Desert Sunlight Solar Farm Project California Desert Conservation Area Plan Amendment and Final Environmental Impact Statement

April 2011
CACA #48649

Appendix M

Comment Letters

Image taken from base of Coxcombs – JoTr Wilderness

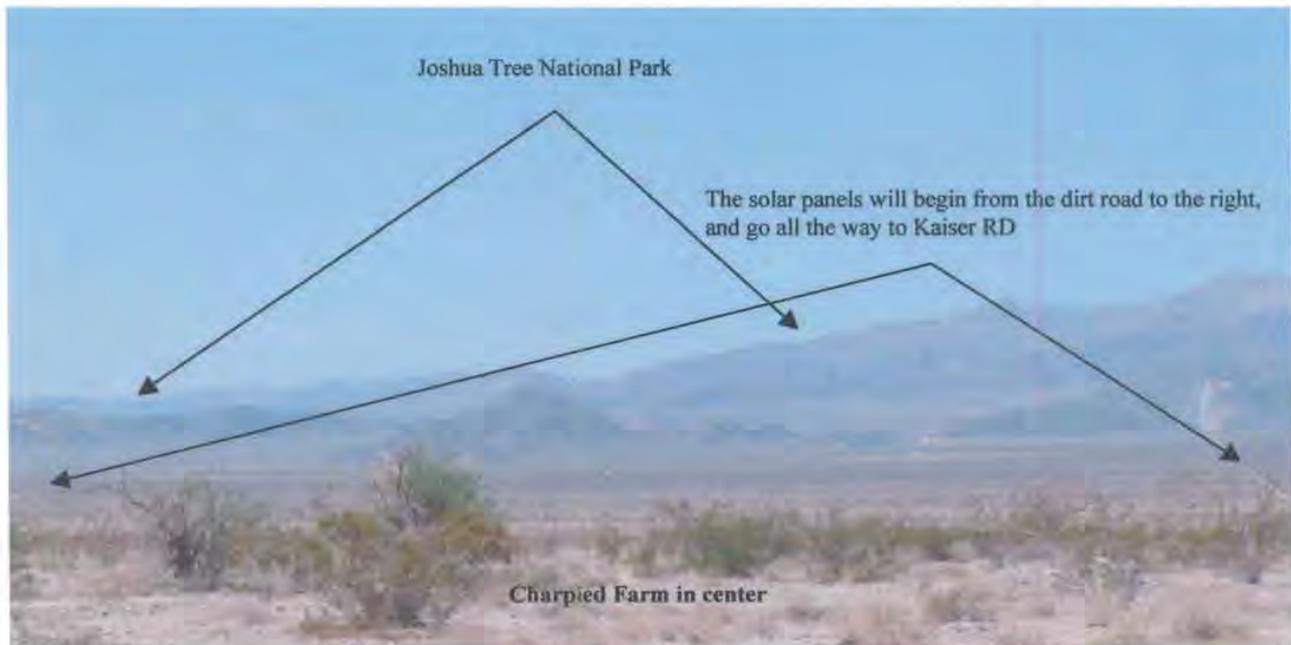
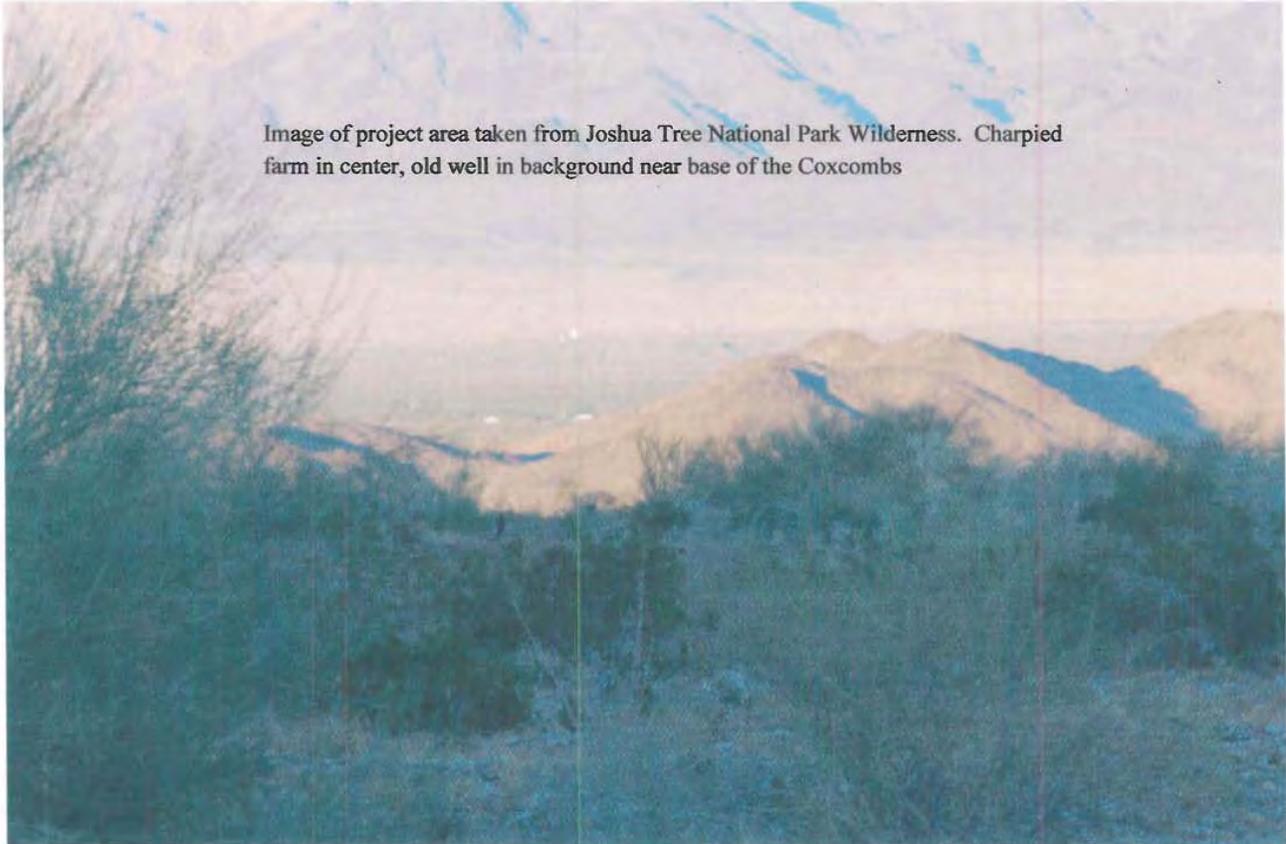
Key Observation Points (“KOP”) that we viewed during the BLM meeting in Desert Center never even attempted to show the project to sensitive receptors. Not one image was taken from private property lines. Further, the private property owners in Section 16 would have to be blind not to see the mirrors. The Charpied’s will not only see the panels, they will hear the constant hum of the transformers and have their eyes assaulted by transmission lines, and panels where Joshua Tree National Park Wilderness once painted the scenery. A visitor’s wilderness experience in Joshua Tree National Park will be impugned.

project 54881
contract
dwg. no. rev. TAN-1 - 1

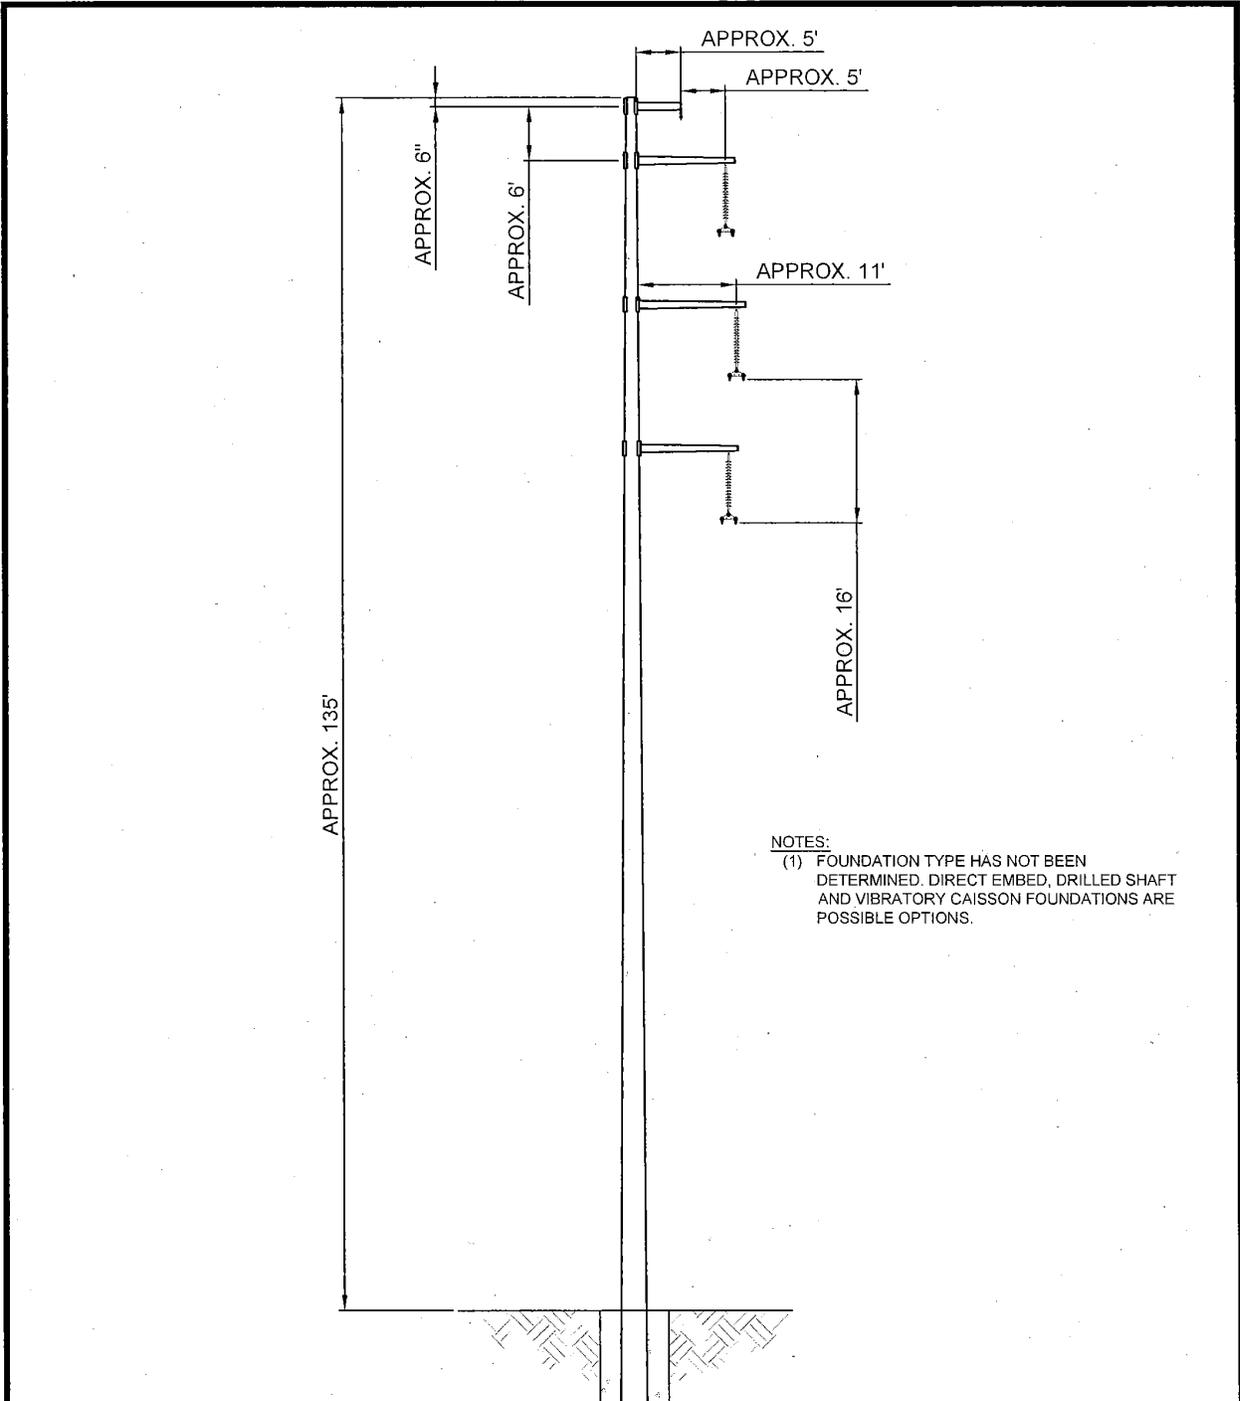
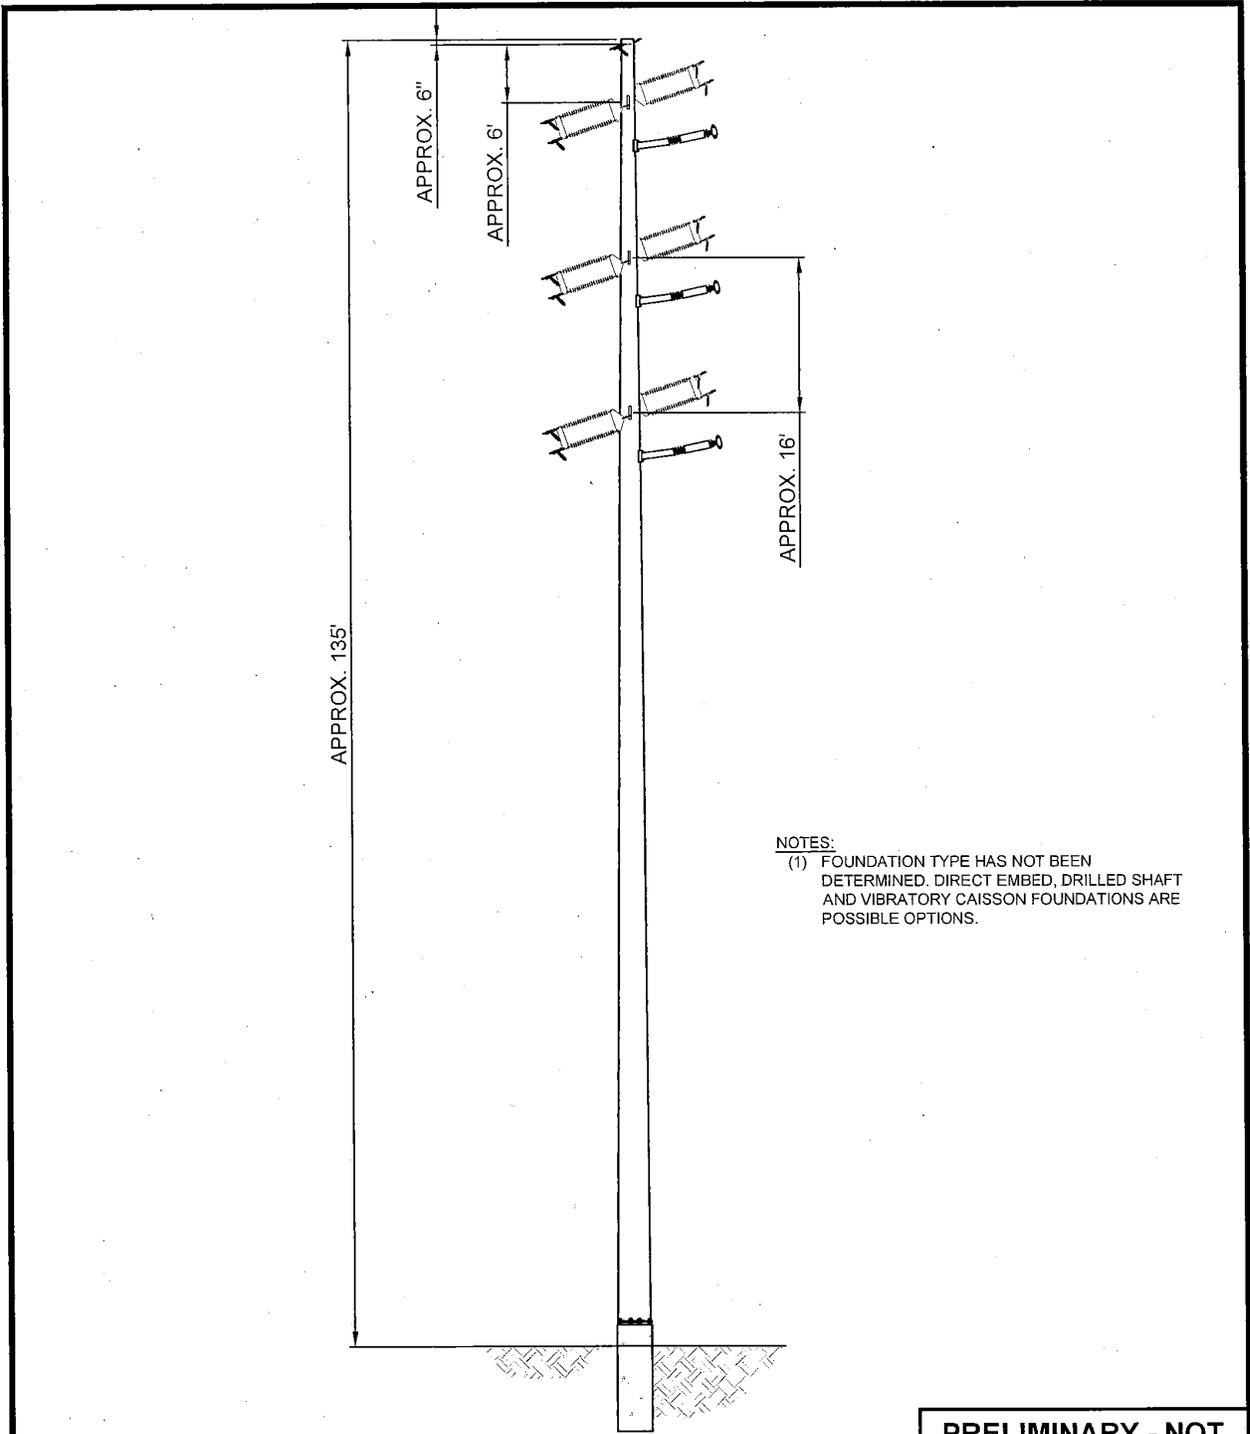
2.2.3, p. 2-18, second paragraph of “Transmission Line” section and Figures 2-10/2-11. First Solar has revised the design of the Gen-Tie poles from a delta to vertical configuration. We are therefore submitting revised figures to replace Figures 2-10 and 2-11, which are new figures TAN-1 and DE-1, respectively, and which are attached to this submittal of DEIS comments. This design change does not impact the height or footprint of the poles, the typical spacing between the pole structures, or the construction process for the Gen-Tie. The text in the second paragraph should be revised with the following:

See attachment A (TAN-1 and DE-1 to replace Figures 2-10 and 2-11, respectively).

“The Applicant plans to use steel monopoles for the Gen-Tie Line. Poles are expected to be approximately 135 feet tall. Typical 220-kV poles designed with a vertical configuration are shown in Figure 2-10 and Figure 2-11. Typical spacing between structures would be approximately 900 to 1,100 feet. Self-weathering steel would be used for the monopoles, which would blend with the surrounding mountains better than other potential finishes. Self-weathering steel is composed of a special alloy that forms an oxide, which prevents further rusting. The finish appears as a matte patina and is commonly used in environmentally sensitive areas where a shiny appearance would be undesirable.”

Figure 3.9-4

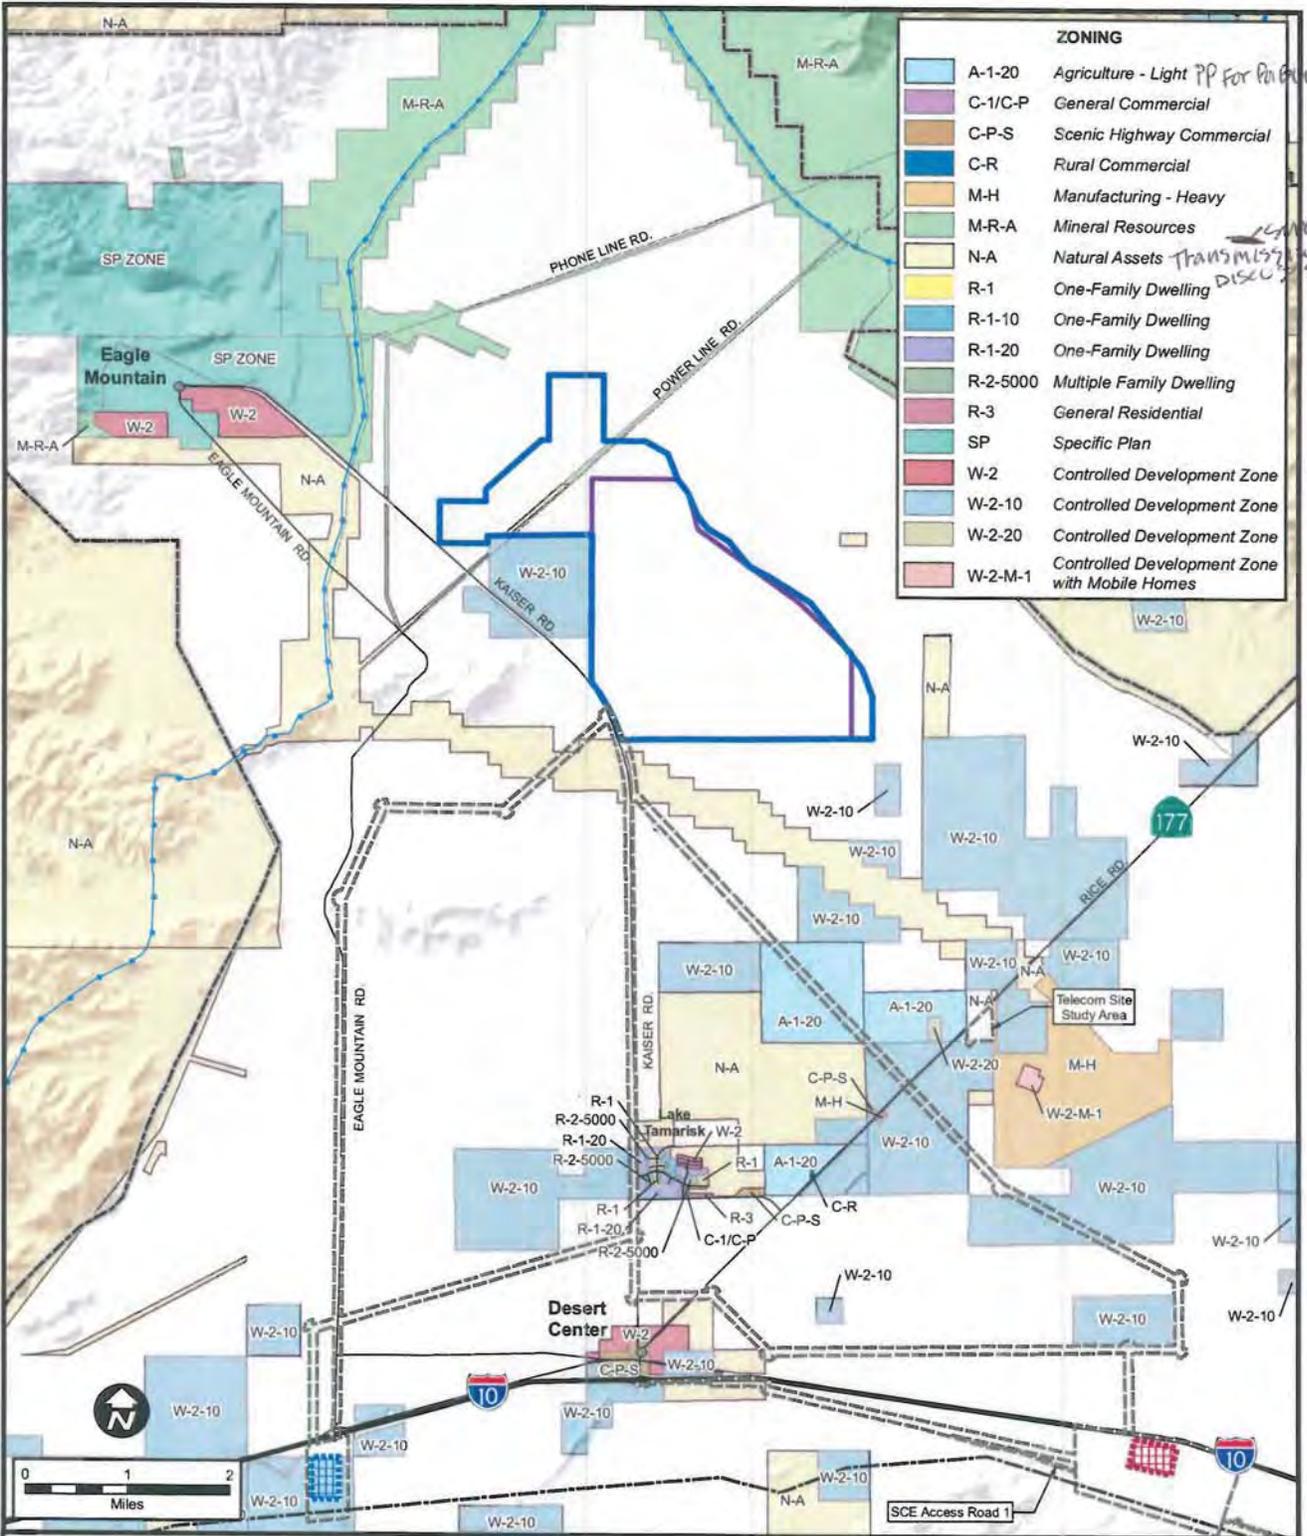
GT-B-2 would cross and encroach on the county roadway easements for Kaiser Road and Eagle Mountain Road as well as land owned in fee by MWD. The approximate aggregate gross acreage of these crossing and encroachments is 101 acres. The table below provides a list of the APN's and associated Section, Township and Range where crossings or encroachments would occur:
